MARK	DATE	DESCRIPTIONS	BY	CH'D	CCO#
2	07/12/13	MISCELLANEOUS SCADA CHANGES	RR RSB	RG	305
1	05/13/13	MISCELLANEOUS SCADA CHANGES	RR RSB	RG	305
0	06/23/10	DEHUMIDIFIER SCADA INTERFACE	RR	RG FW	130

CONTRACT CHANGE ORDER NO. 305
SHEET 2 OF 23

DETAILS
TOWER AND SUSPENSION CABLE TOWER POWER AND LIGHTING
NN SCALE

CONNECTION DIAGRAM - RTU #11E

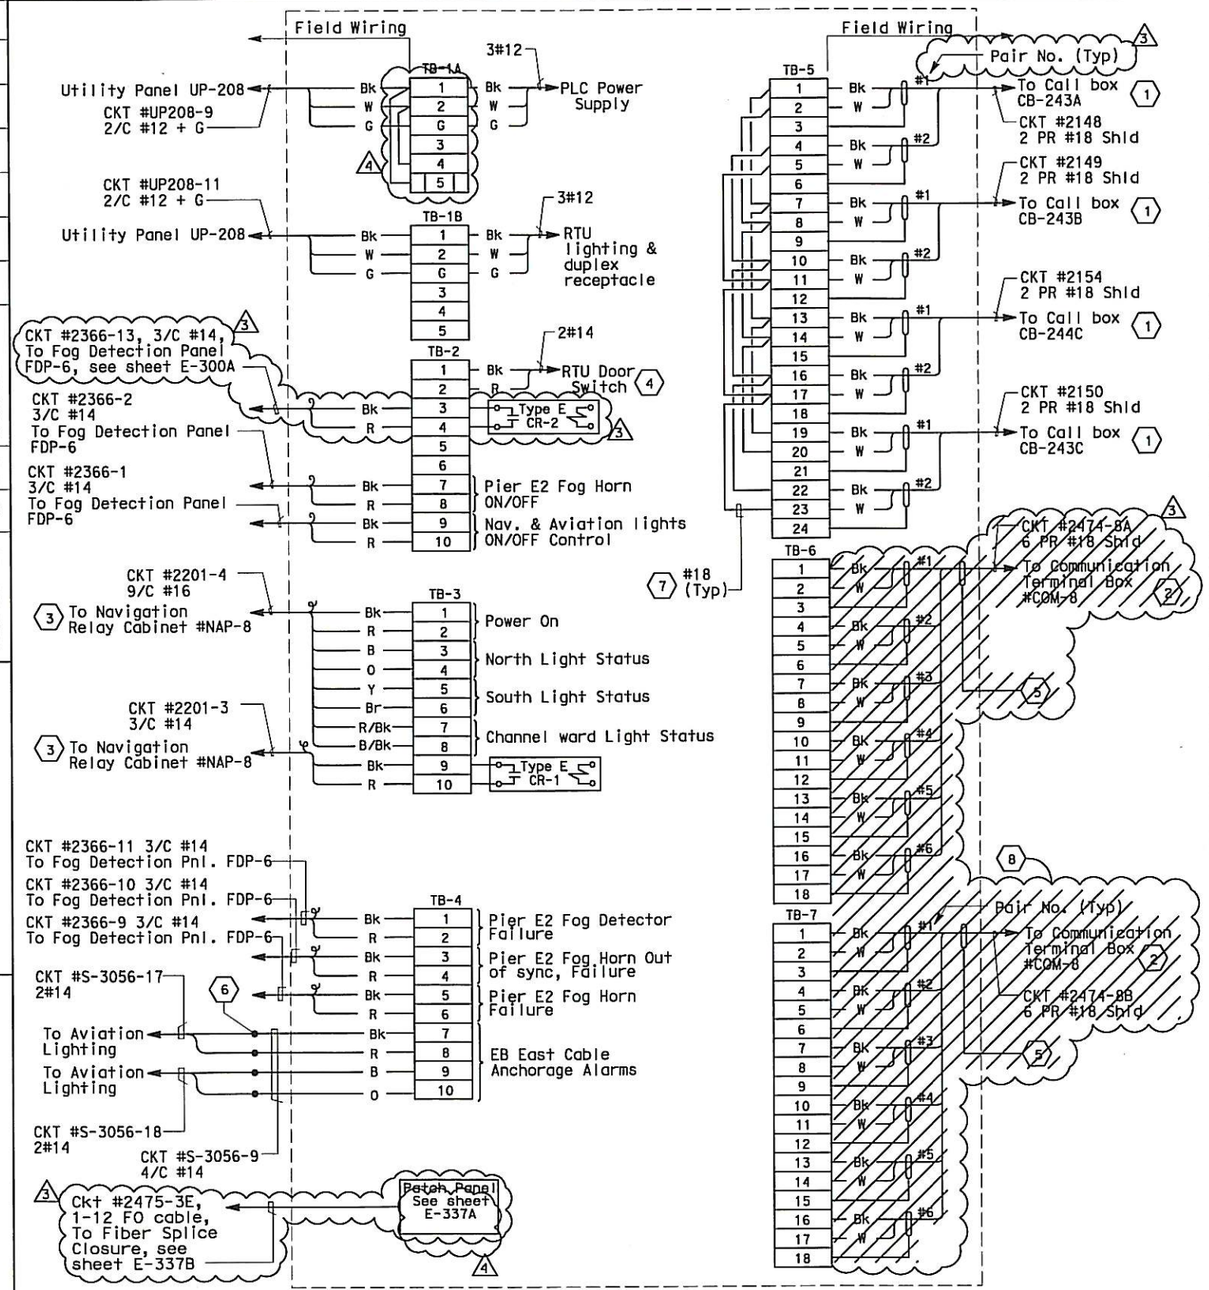
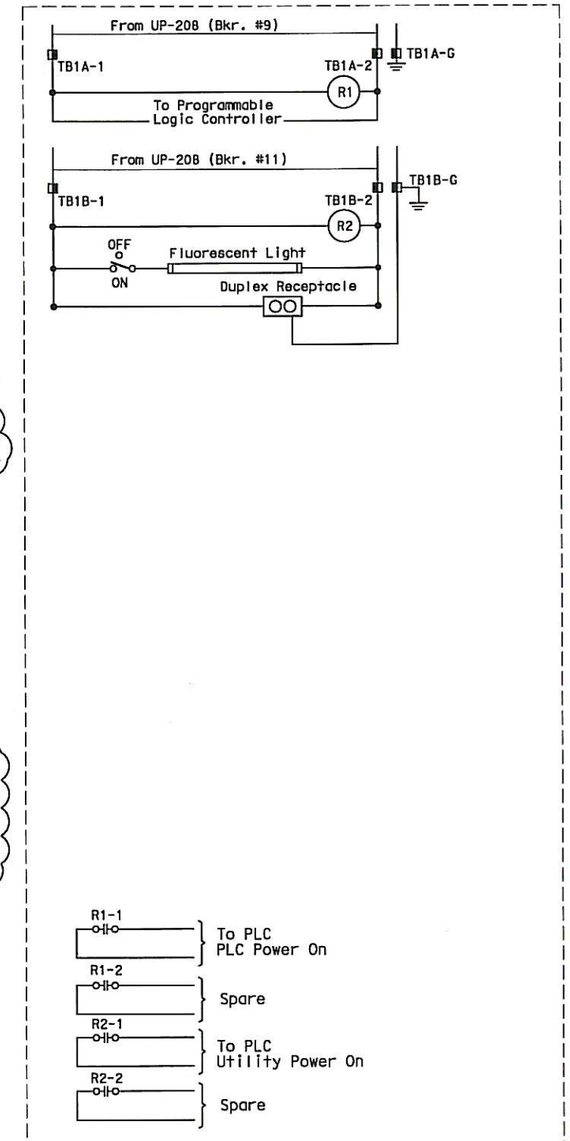
1. For connection diagram to call boxes, see sheet E-400.
2. For connection diagram to scada system, see table A, sheet E-325. (3)
3. For connection diagram to navigation system, see sheet E-303.
4. Connections to panel door switch. For remote alarm status to RTU.
5. Field to tape cable overall shield wires. (3)
6. Conductors spliced inside junction box PB-2A located inside the girder.
7. The Contractor shall install resistors, approximately equal to the impedance (Zo) of the twisted pairs, at the extreme ends of the multidrop network.
8. Abandon in place (hatched items) if installed. (3)

MARK	DATE	DESCRIPTIONS	BY	CH'D	CCO#
4	07/12/13	MISCELLANEOUS SCADA CHANGES	RR RSB	RG	305
3	05/13/13	MISCELLANEOUS SCADA CHANGES	RR RSB	RG	305
2	08/03/09	ELECTRICAL WARNING SYSTEMS	RG	JE FW	61
1	03/04/08	BARRIER MODIFICATIONS	JS BM	RG SE	44
